Addendum 5
TFM-009-24 – GRD-508-23: Concrete & Asphalt Repairs 2024

PROJECT NAME:
CONCRETE AND ASPHALT REPAIRS 2024
Project #: GRD-508-23

Addendum 4
TFM-009-24 – GRD-508-23: Concrete & Asphalt Repairs 2024

NEW CONCRETE SLAB SECTION
SCALE: 1:10

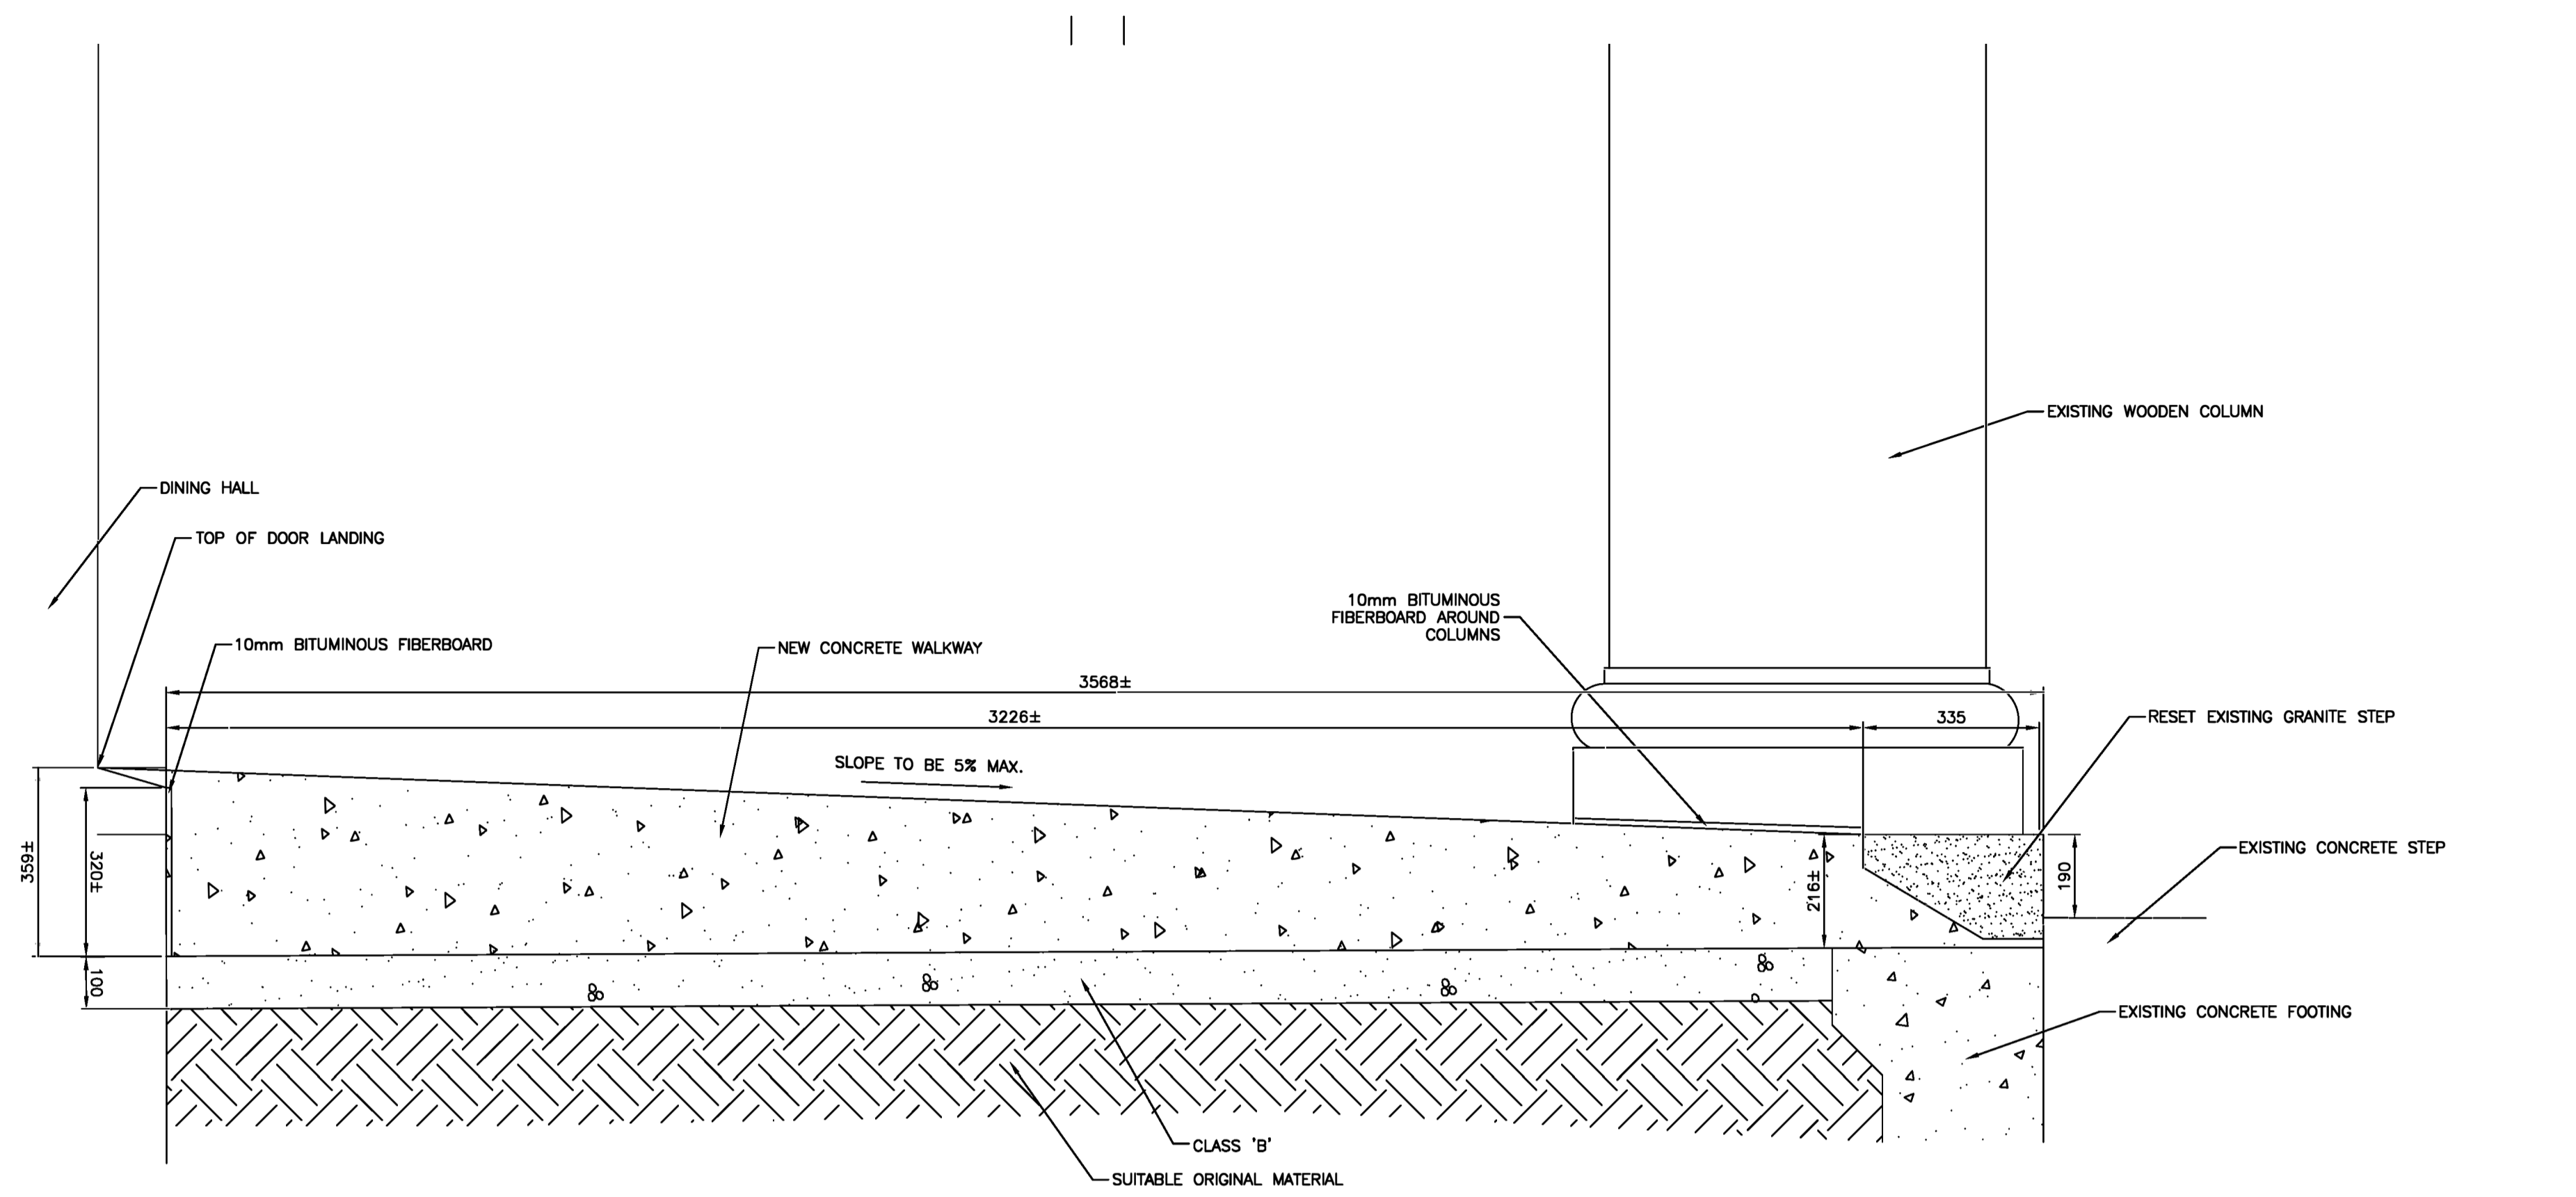
- .1 ADD Drawing C-2.2-R0 (Addendum 4 referenced incorrect new drawing number. Drawing C-2.1-R1 remains unchanged.)

EXISTING COLUMN ELEVATION AND PLAN DETAILS
SCALE: 1:20

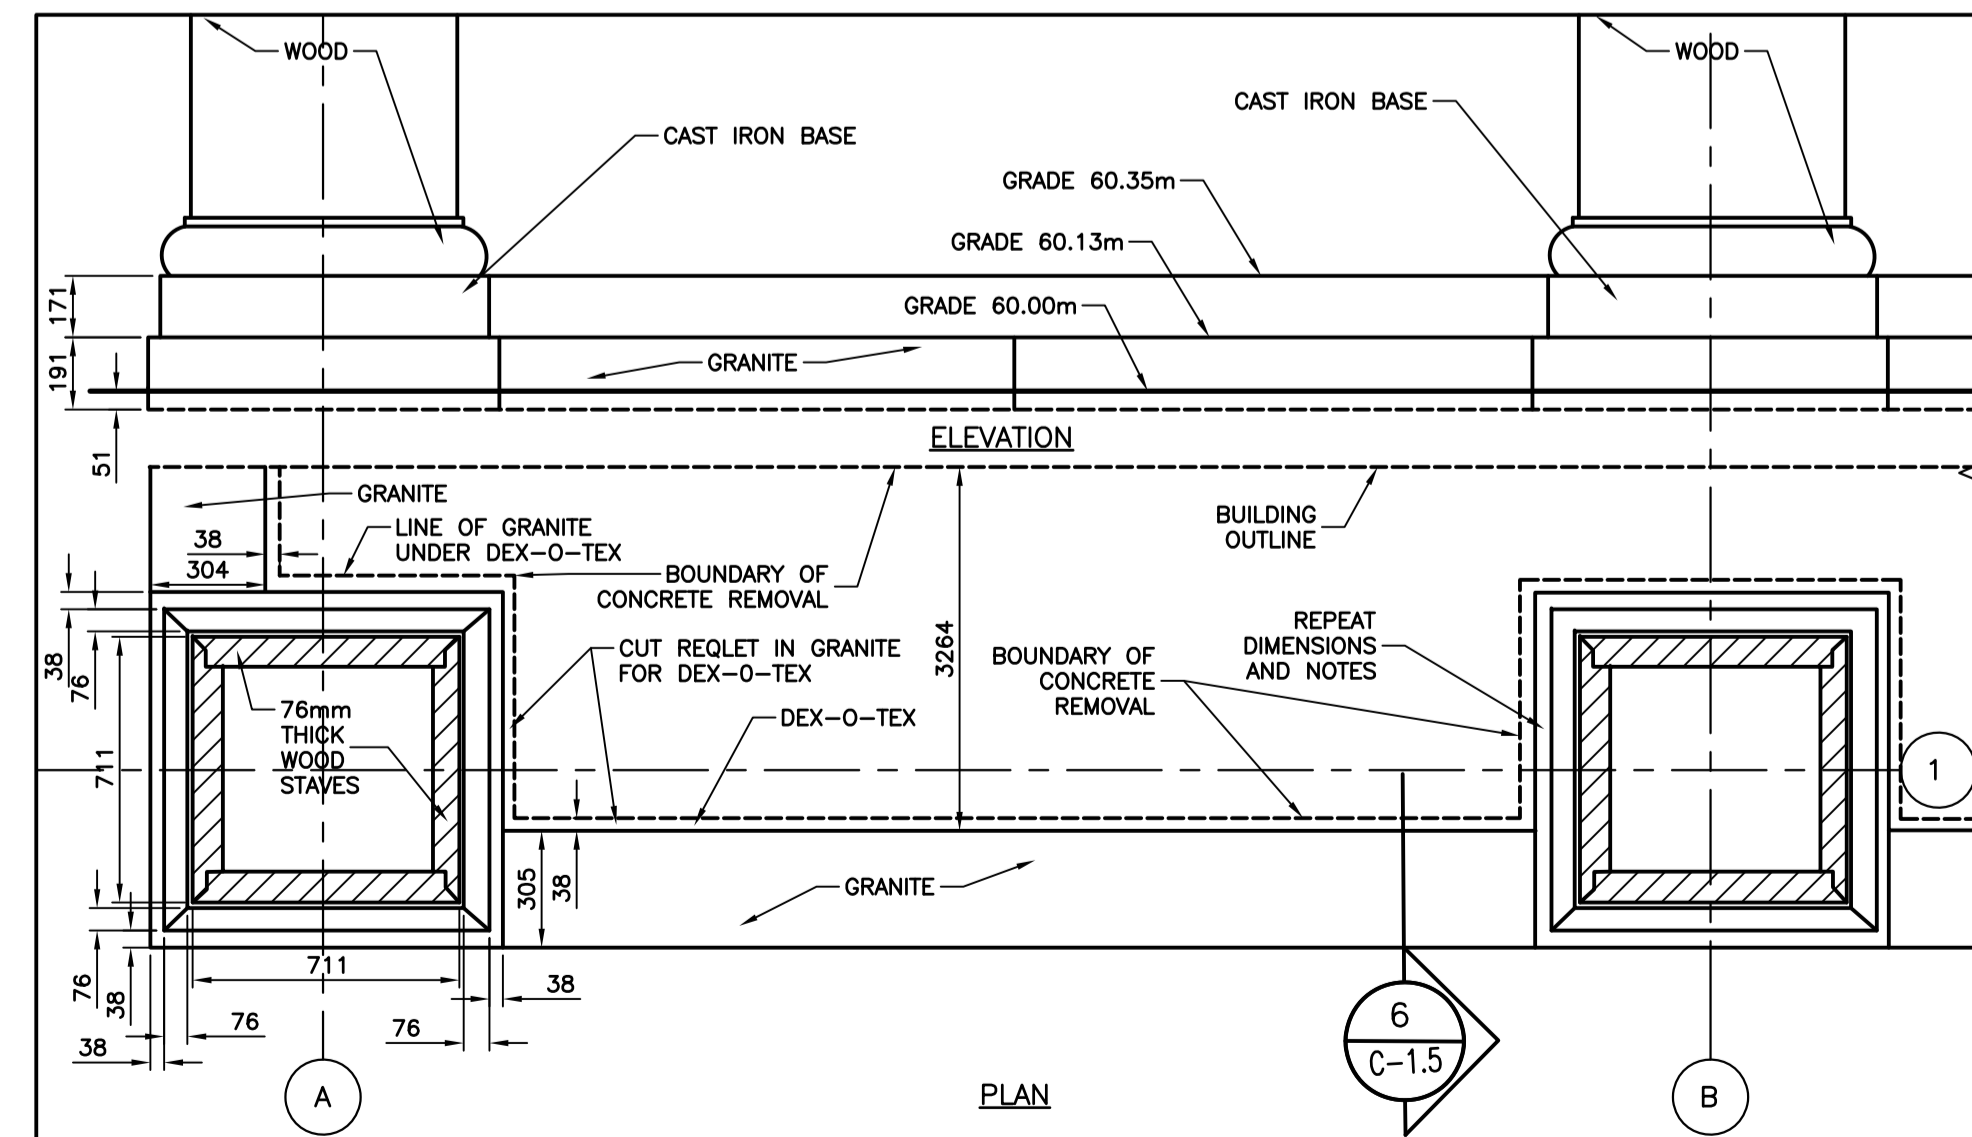
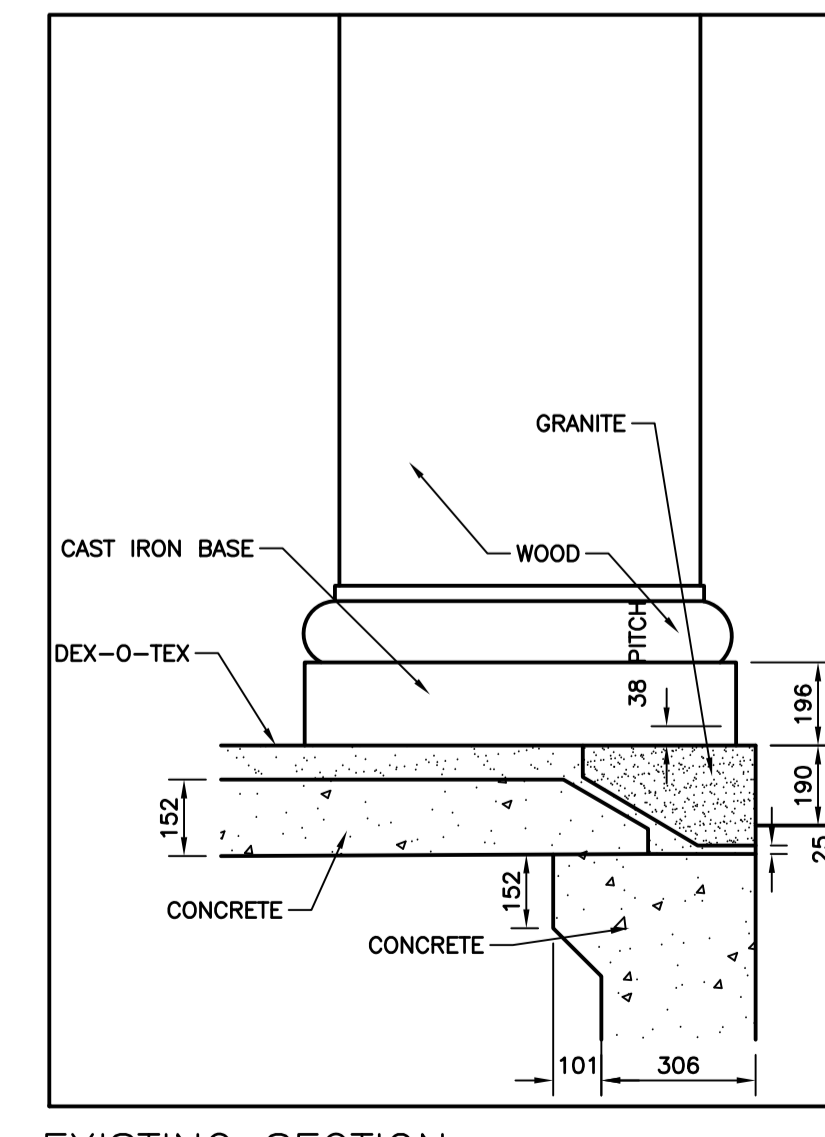
REVISE RESPONSE TO QUESTION 1.7.16 IN ADDENDUM 1 AS FOLLOWS:

RESPONSE: Refer to Details 5 & 6 on drawing C-1.5-R2 for more information on the work area and the interface with the columns. Fibre board is to be installed around the inside perimeter of the Main Dining Hall columns, at the interface with the slab. The Main

Dining Hall is operational throughout the summer. However, during the construction works the south entrance can be closed and alternate entrance, with appropriate signage, can be used. The contractor is required to submit a comprehensive schedule for the scope of works and the owner will facilitate any coordination needed with the users of the area.
